**SIX SENSES HOTEL**  
LOT 109R MOUNTAIN VILLAGE, CO

- LOT 109R MAJOR PUD AMENDMENT SPECIAL HEARING SUBMITTAL 05.19.2022
- LOT 109R PUD AMENDMENT TOWN COUNCIL SUBMITTAL 06.07.2022
- LOT 109R PUD AMENDMENT TOWN COUNCIL CONTINUANCE SUBMITTAL 08.08.2022
- LOT 109R PUD AMENDMENT FINAL DRB SUBMITTAL 10.21.2022
- LOT 109R PUD AMENDMENT TOWN COUNCIL SUBMITTAL 12.16.2022

FLOOR PLAN - LEVEL 6 - OVERALL

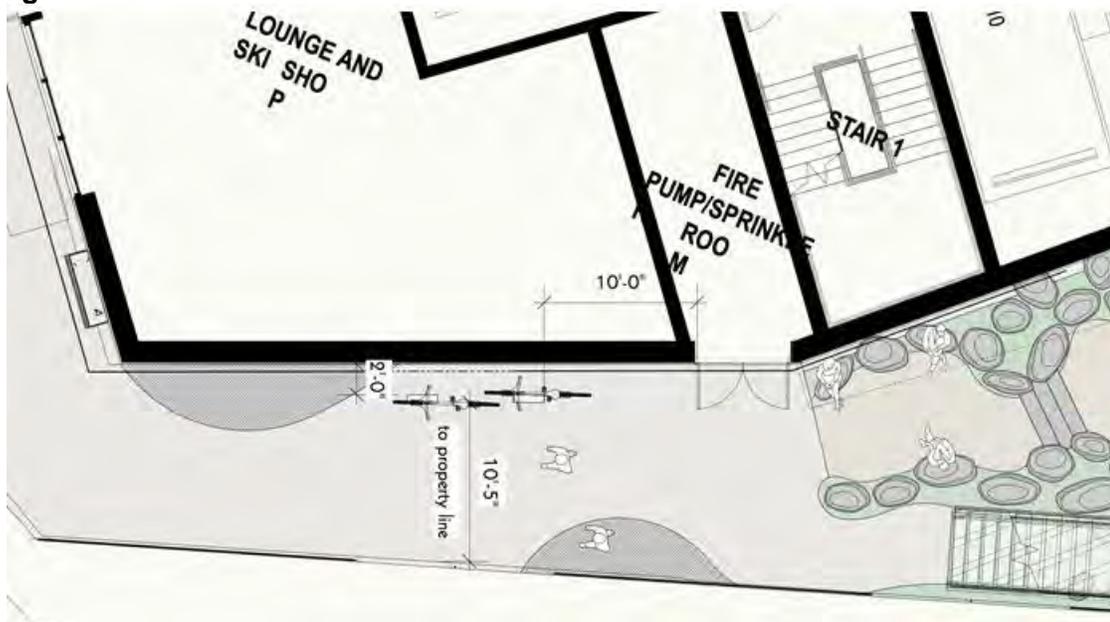
**Marpa Response: Bike racks have been rotated 90 degrees to, please see revised diagram below.**
